工程指示 / 要求簡箋(E.I.)

工程指示編號：EI / 3758 / 21

工程名稱：亞皆老街中電

工程項目：百葉 後加百葉鋁料(T3, UR/F、T1,2 R/F、T1,2,3 23/F) (7 隻)

鋁材開料總表

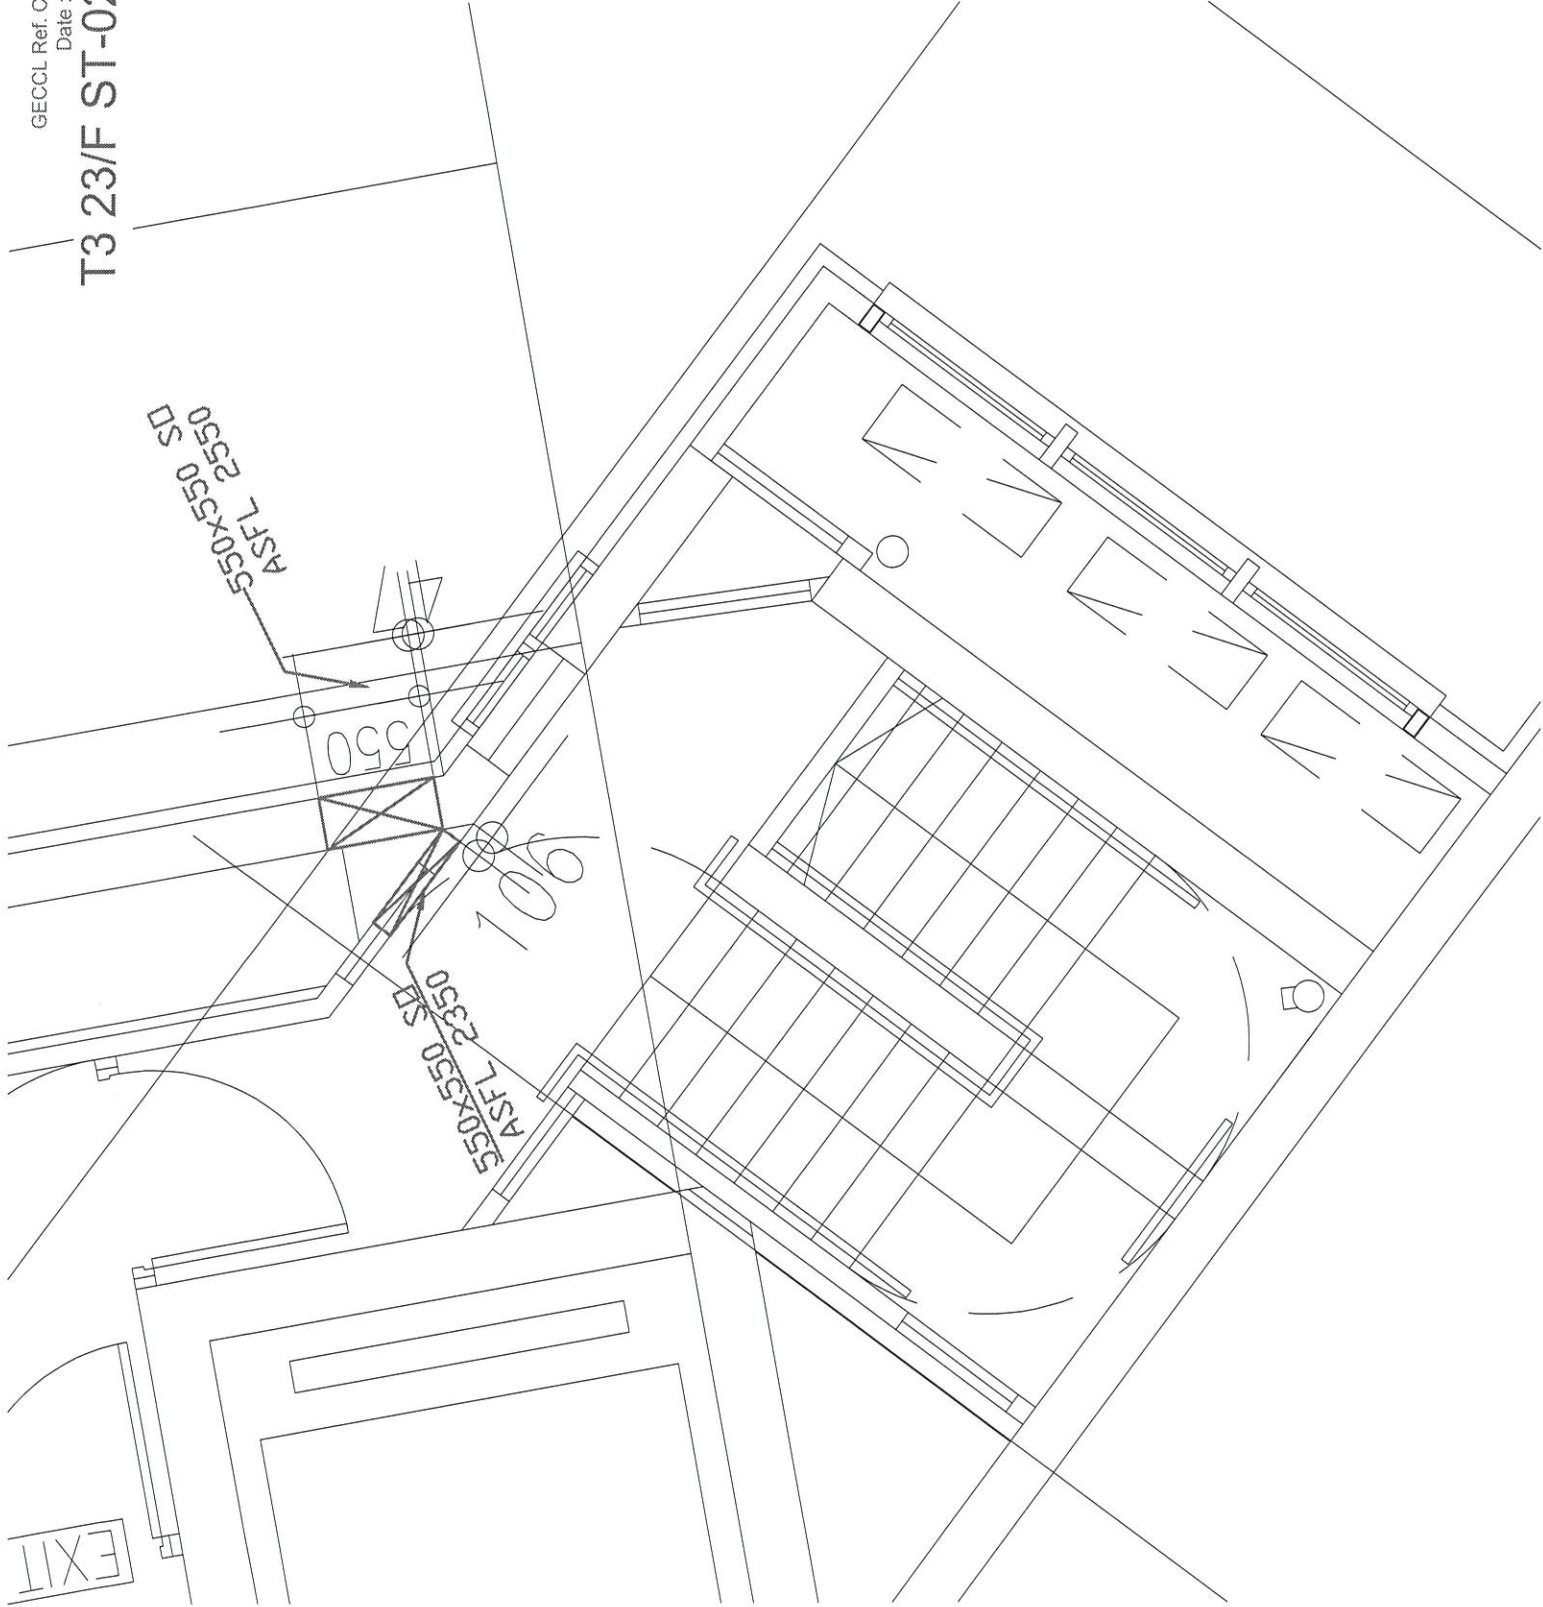
Further to telephone conversation with AGC on 12 August 2021, additional opening (550x550 S.O.) and louvre (500x500) to be supplied and installed by Midi was confirmed to be constructed for top vent at T1-T3 TR/F ST-01 and T1-T3 23/F ST-02.

550x550 opening
at +105.075 BL

ASFL 2550
550x550 SD
